Access Compliance Report

Public Rights-of-Way

Intersection ID: 27369	Main Street: JORDAN_RAE_LN	Cross Street: MEADOW_RUN_LN	Location: NE
ADA ID: 89BFE7399632	Ramp Type: Perp	Initial Pass/Fail: Fail	Overall Compliance: No
		Severity Score: 8.75

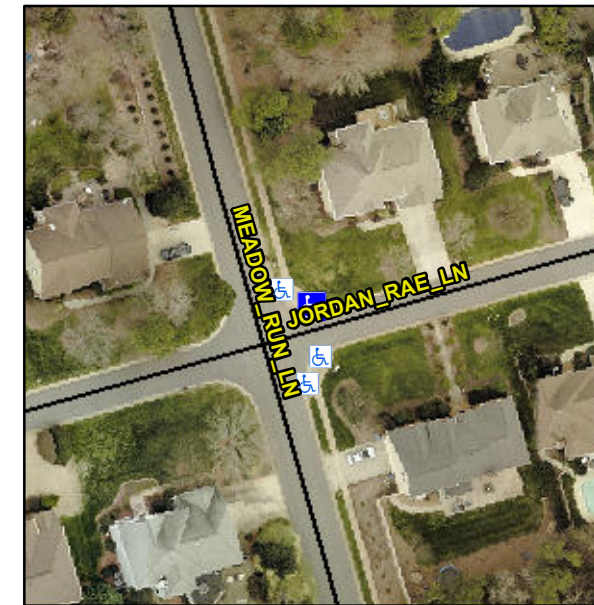
Not Found, R304.5.1

Compliance	Description	Data	Compliance	Description	Data
N/A	Ramp Length (in)	95.0	Yes	Ramp Slope (%)	5.7
No	Ramp Width (in)	39.0	Yes	Ramp XSlope (%)	1.0
N/A	Flare Type LT	N/A	N/A	Flare Type RT	N/A
N/A	Flare Slope LT (%)	N/A	N/A	Flare Slope RT (%)	N/A
N/A	Flare Traversable LT?	N/A	N/A	Flare Traversable RT?	N/A
N/A	Landing Length (in)	N/A	N/A	DWS Provided?	N/A
N/A	Landing Width (in)	N/A	N/A	DWS Contrast?	N/A
N/A	Landing Slope (%)	N/A	N/A	DWS Length (in)	N/A
N/A	Landing X Slope (%)	N/A	N/A	DWS Full Width?	N/A
N/A	Landing Curb? (Y/N)	N/A	N/A	DWS Offset (in)	N/A
N/A	Shared Landing?	N/A			
N/A	Gutter Ponding?	N/A	N/A	Gutter Slope (%)	N/A
N/A	Gutter Lip Ht (in)	N/A	N/A	Gutter X Slope (%)	N/A
N/A	Painted X Walk1?	No	N/A	Painted X Walk2?	N/A
	X Walk 1 Direction	To S		X Walk 2 Direction	N/A
N/A	X Walk 1 Width (in)	N/A	N/A	X Walk 2 Width (in)	N/A
	X Walk 1 Slope (%)	1.1		X Walk 2 Slope (%)	N/A
	X Walk 1 X Slope (%)	2.8		X Walk 2 X Slope (%)	N/A

Remove & Replace Entire Ramp.
